Document Order No.: DD+DIS123.00E

ADC Solo
Type: 5155

Modification Instructions

Exchange of Display Cover

Figure 2

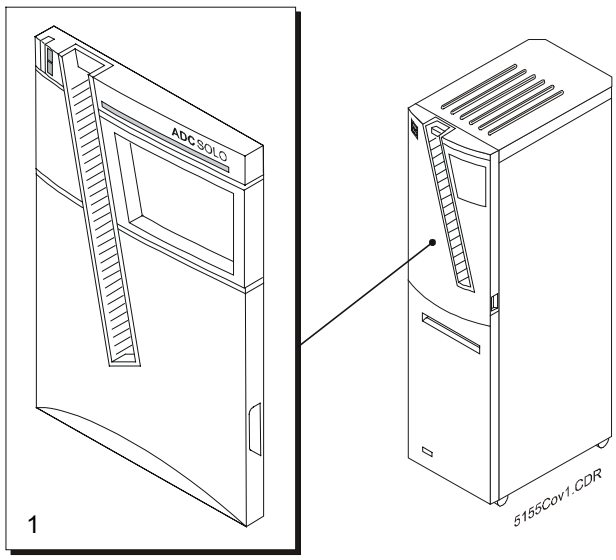
Alternative 1
If no display covers are on stock or if the locking mechanism is broken: Exchange the entire front panel (CM+ 9.5155.1210.2).

1. Remove the right side panel (without tools).
2. Turn the screws of the left panel (quarter turn).
3. Remove the left side panel.
4. Open and remove phillips screws of top panel at rear of the digitizer.
5. Lift top panel and slide it towards the rear.
6. Open the three phillips screws along the left side and the three phillips screws along the right side of the front cover. Be careful with the washers.

7. Open the front door at the bottom of the digitizer.
8. Remove the front panel to be exchanged.
9. Insert the new front panel in reverse order of the described steps.
10. When you insert the new front panel make sure that the bores are in the right position.

Figure 3

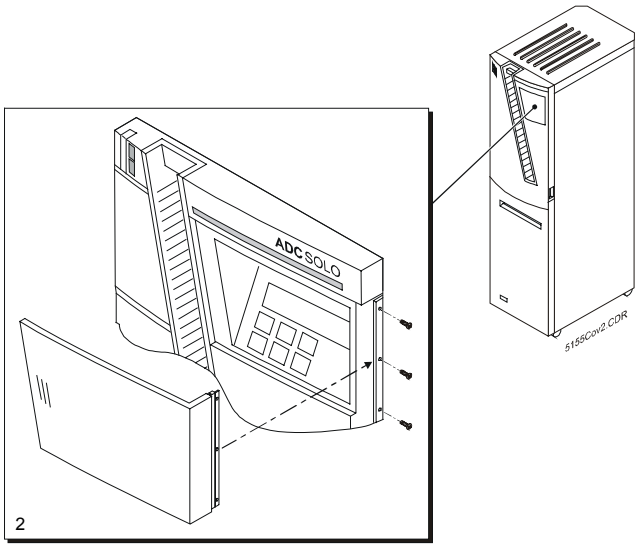
If display covers are on stock and the hinge of the display cover is broken: Exchange the complete display cover including the hinge (CM+9.5155.9060.1).

1. Remove right side panel.
2. Remove the three phillips screws of the plastic hinge. Use a phillips screw driver.
3. Pull the old hinge out of the frame.
4. Insert the new hinge into the frame.
5. Fix it with the phillips screws.

Figure 4

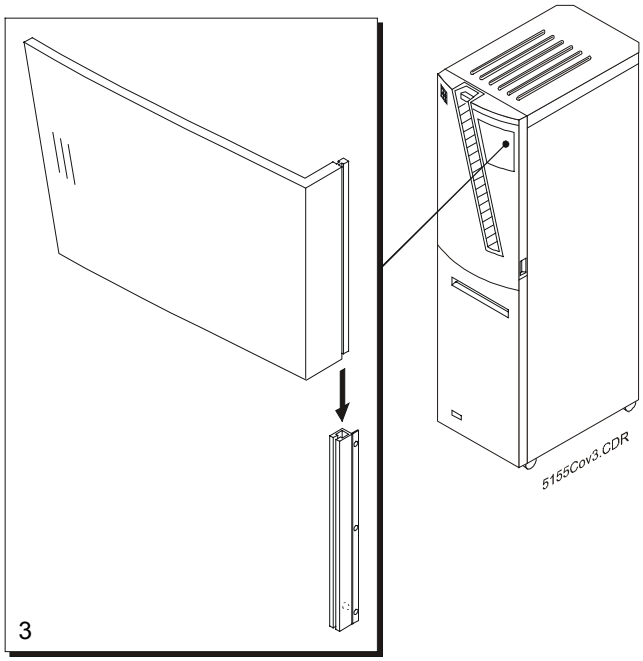
If display covers are on stock and the hinge of the display cover is not broken: Exchange the display cover only (CM+ 9.5155.9060.1).

1. Open the display cover.
2. Hit it gently but determined either from top or bottom and remove the old display cover by sliding it out of the hinge.
3. Insert the new display cover by sliding it into the rail of the hinge. Slide it until it exactly reaches the level of the hinge.
